GSM SERVICE SUPPORT GROUP	2003.08.11
C370 / C450	Rev. 1.0
Alexander Buehler, Michael Hansen	8486778P01Rev0
	Page 1 of 1

C370 / C450 V.10 8486778P01Rev0

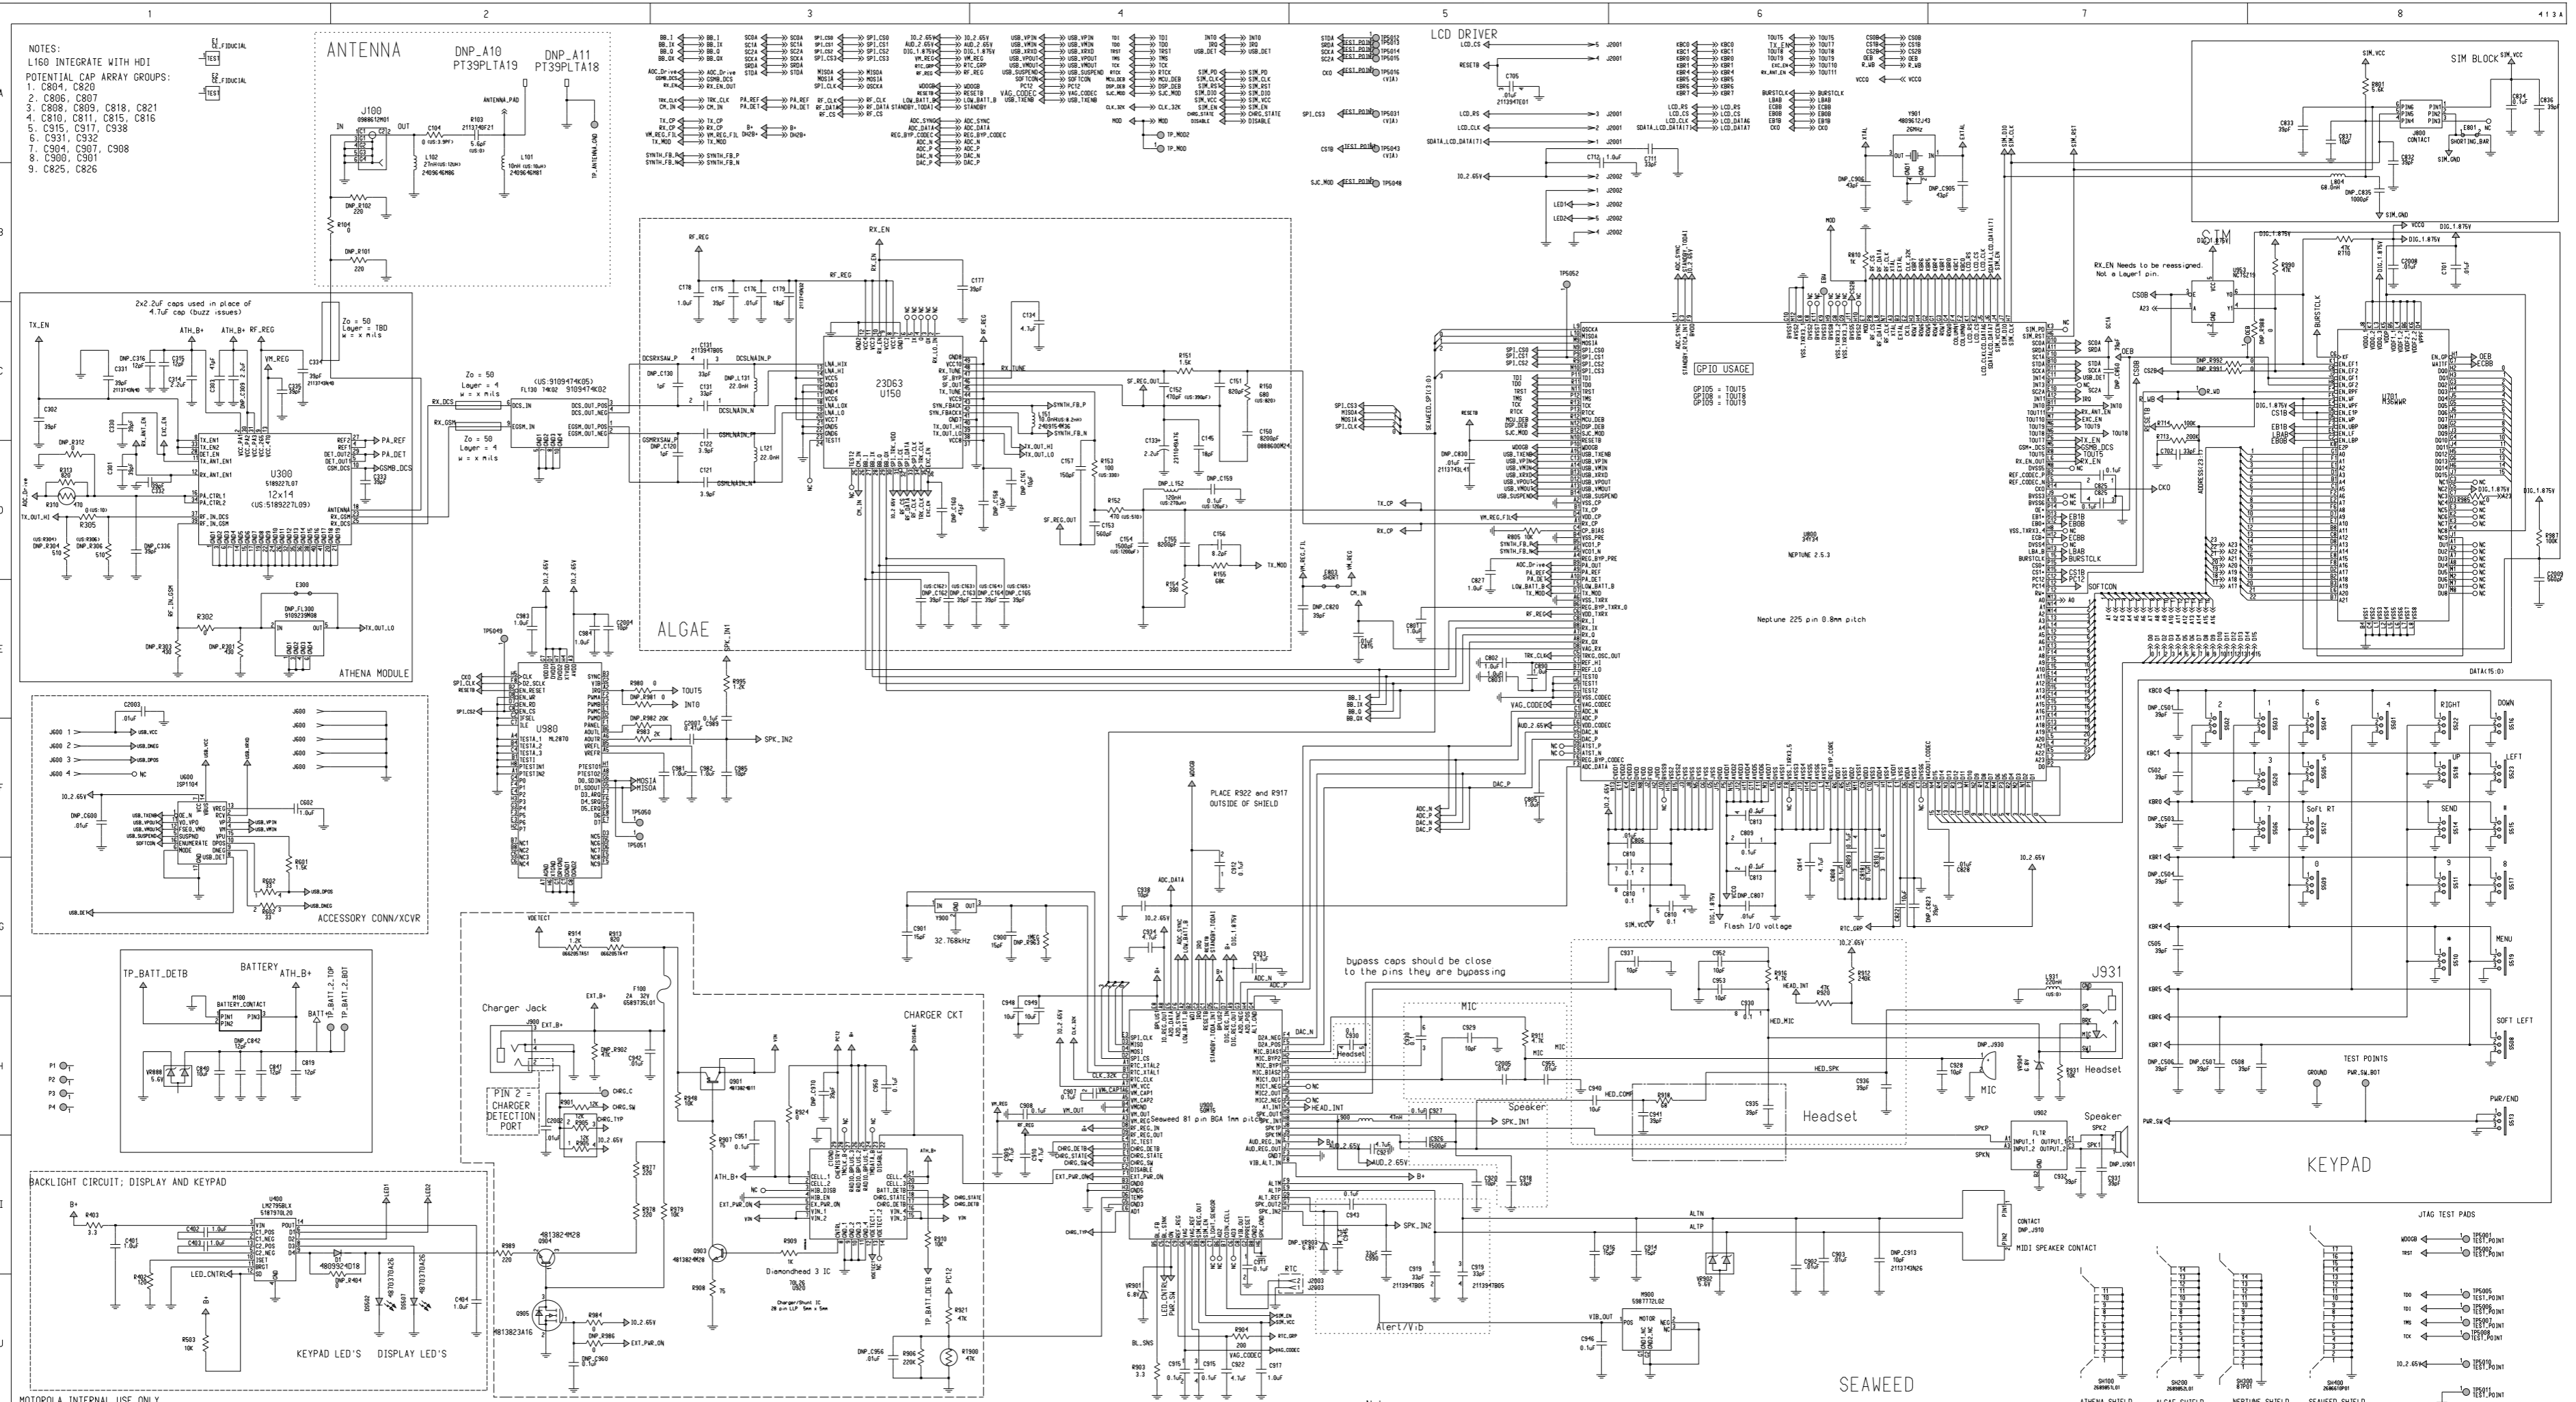
- Notes:
- 1) W00G pin header P910 needs to be removed
 - 2) MOD pull-down resistor needs to be placed (DNP_R810 to R810).
 - 3) DH2B+ Net needs to be renamed to B+ (one place: U920-24,25,26)

- 4) REMOVE DNP_R820 AND DNP_R821
 - 5) ADD SHIELDS SH200, SH300, SH400
 - 6) Delete sheet 2.
 - 7) Add Cxxx (21-xxxxx) to TP_S800_PORT_2.TOP
 - 8) U920-9 TO GND ON LAYER 1
